Well Name: GISSLER A	Well Location: T17S / R30E / SEC 11 / SESE / 32.8446808 / -103.9368257	County or Parish/State: EDDY / NM
Well Number: 29	Type of Well: OIL WELL	Allottee or Tribe Name:
Lease Number: NMLC029338A	Unit or CA Name:	Unit or CA Number:
US Well Number: 300153111100S1	Operator: BURNETT OIL COMPANY INCORPORATED

Sundry ID: 2871356

Type of Submission: Notice of Intent	Type of Action: Plug Back
Date Sundry Submitted: 09/03/2025	Time Sundry Submitted: 12:46
Date proposed operation will begin: 12/05/2025

Conditions of Approval for Permanent Abandonment of a Production Zone

PROPOSED WBD

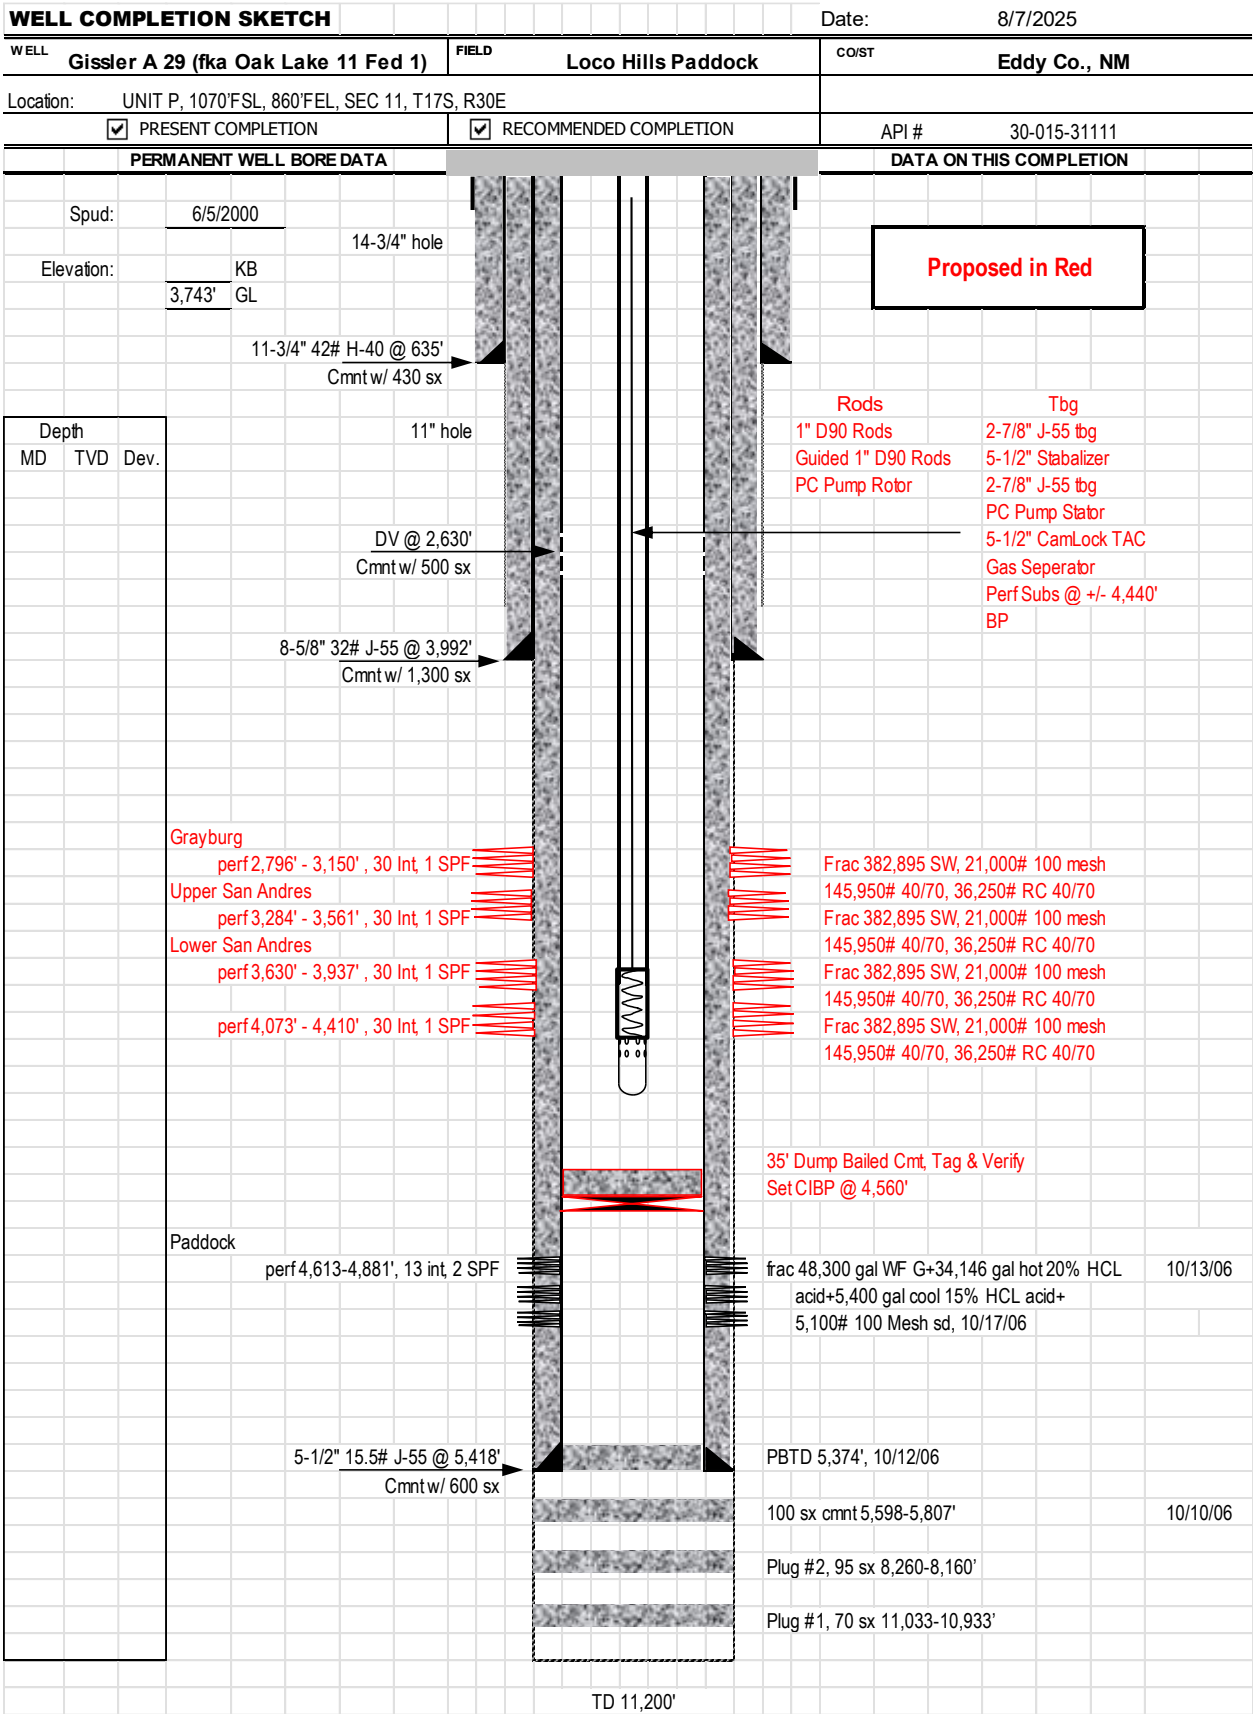
Well in Lesser Prairie Chicken Area. Please review additional requirements in COA below

Please review BLM conditions of approval following this procedure below.
Existing Open Perfs: 4,613-4,881'

- 4) MIRU WL. RIH & set 5-1/2" CIBP @ +/- 4,560'. Dump bail 35' cmt on top of CIBP, verify Top of cmt. **Spot Class C cement from 4560' to 4300' on top of CIBP, verify Top of cmt 4300' or shallower. Covering Glorietta top**
